M9037A-05

Modification Recommended Service Note

M9037A PXIe High Performance Embedded Controller

Intel Active Management Technology Escalation of Privilege

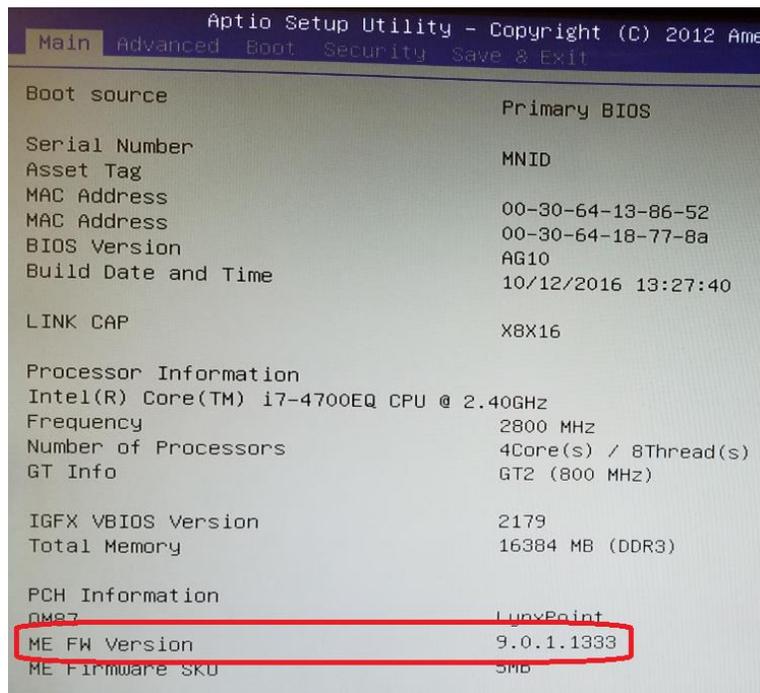
1. Power on or reboot your embedded controller.
2. Press the <Delete> key when the controller beeps. This should be concurrent with the main startup screen. The BIOS setup program loads after a short delay.
3. At the BIOS Main Setup screen, verify that the “ME FW Version” is version 9.1.41.3024 or later. Below picture shows that this controller is vulnerable.

Option 1: Update the ME FW to version 9.1.41.3024 using Keysight ME update tool below.

1. Save and close all your application programs.
2. Download and unzip the [ME_update.zip](#) file to your embedded controller hard drive.
3. As Administrator, navigate to where you unzipped the file and run the ME_update/ME_Update.bat file.
4. At the Command Prompt window, do not interrupt the run. The controller will automatically restart after it's done with the FW update.
5. Verify your embedded controller is not vulnerable with the steps above in the Situation section.
